Clarification on Cooperative Relaying

NSN, Samsung Thales, ETRI

This contribution is a response to comments regarding cooperative relaying (306, 977, 978, 979). Some changes build on top of 545r3 (accepted in batch resolution). Other changes in this contribution deal with clarification in Section 8.4.8.10 as well as introduce capabilities negotiation.

Figure 323a—A logical block example of local STC Encoding at RS. ~~The STC Encoder is identical to the encoder in Figure 244 [Figure 301 in Rev2] of Section 8.4.8.1.~~

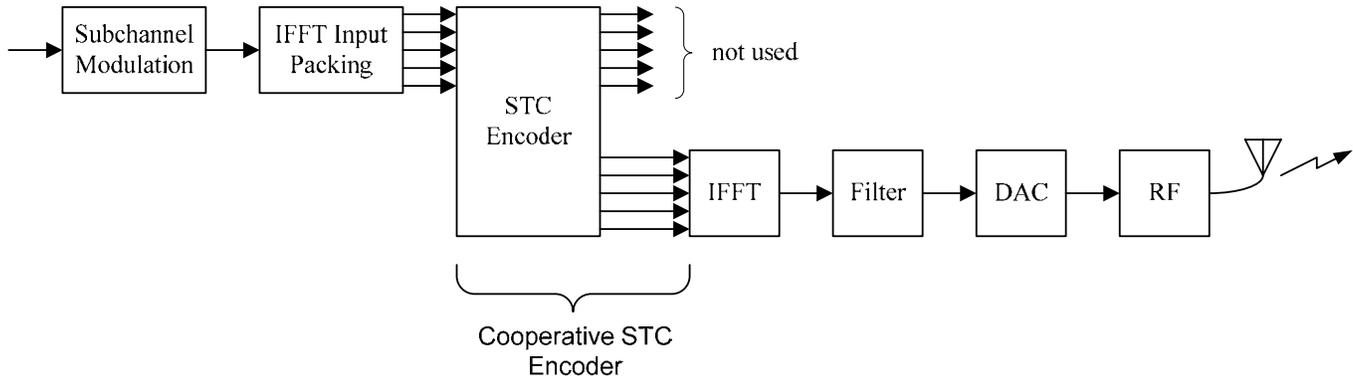
[Change Section 8.4.8.10 as follows]

-Figure 323a is an example of local STC encoding at the RS. The STC Encoder is identical to the encoder in Figure 244[Figure 301 in Rev2] of 8.4.8.1.
